**REVISIONS MADE TO PREVIOUS APPROVED DRAWING HIGHLIGHTED IN GREEN REV CLOUD**

ISSUE	DATE	DRAWN	CHECKED	DESCRIPTION
<b>DRAWING TITLE</b>	GA PROPOSED NORTH-EAST LIGHTWELL 3 - ELEVATIONS			
<b>DRAWING NO.</b>	CTH-PUR-MP-ZZ-DR-A-92109			
<b>REVISION</b>	P01			
<b>SIZE &amp; SCALE</b>	A1L 1:50			
<b>DRAWING STATUS</b>	S4 - Planning

<b>CLIENT</b>	Lendlease
<b>PROJECT</b>	Camden Town Hall
<b>JOB NUMBER</b>	238664

**2 LW.03 - WEST ELEVATION**  
 92109 1:50 @ A1

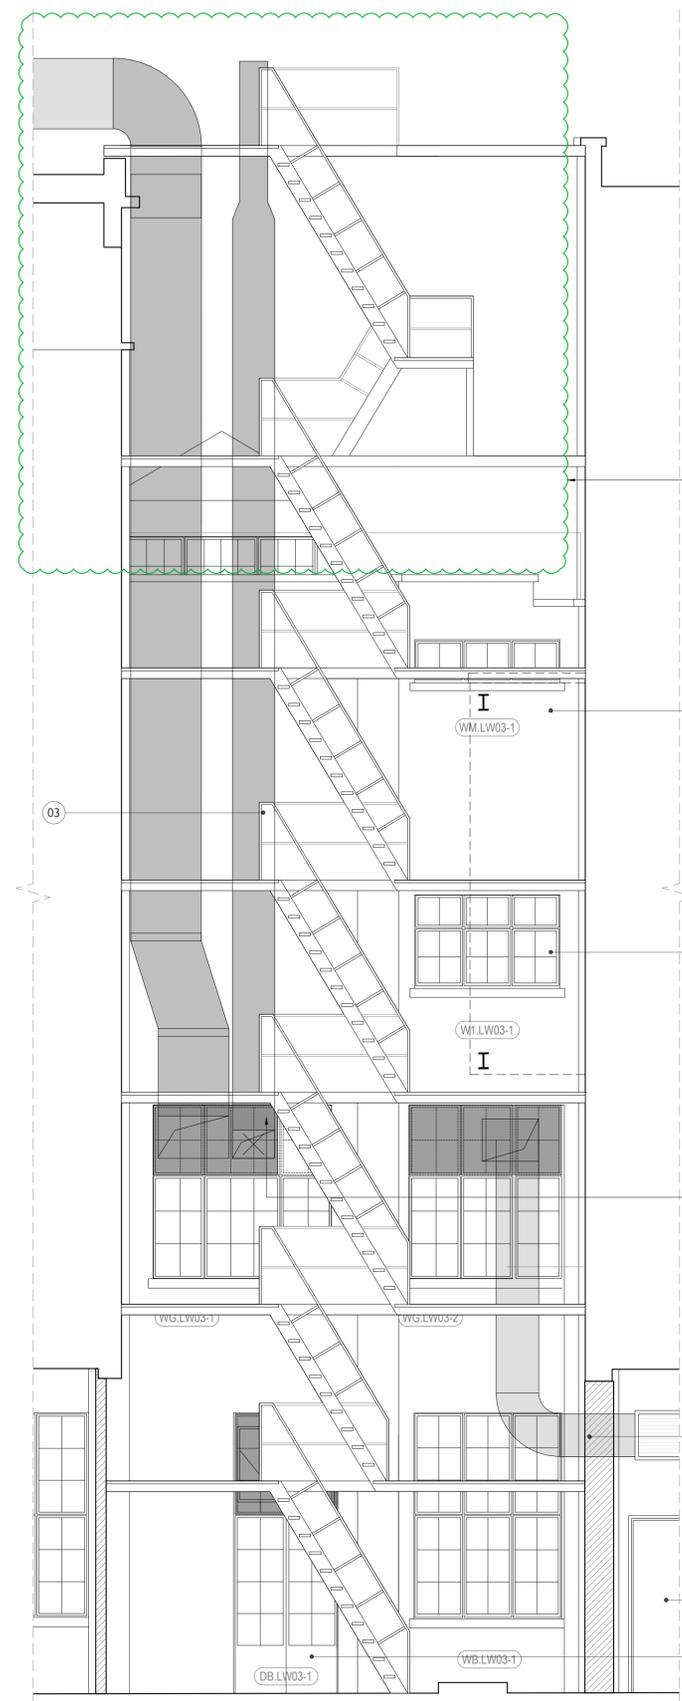
Revision: Mechanical Plant rationalised and reduced duct runs needed.

Revision: Community Space 600mm x 500mm Mechanical plant intake louvre introduced to facade

**1 LW.03- SOUTH ELEVATION**  
 92109 1:50 @ A1

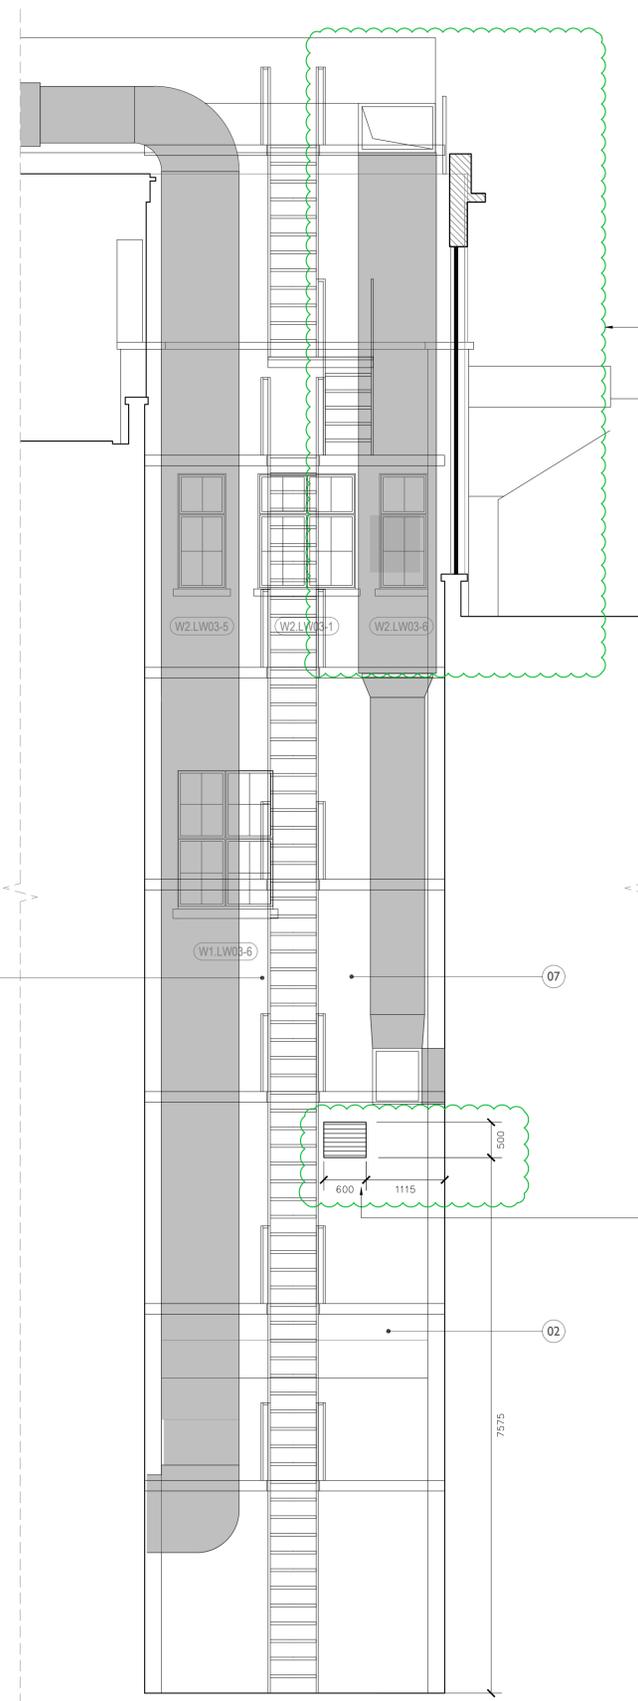
Revision: Mechanical Plant rationalised and reduced duct runs needed.

Revision: Community Space Mechanical plant exhaust duct
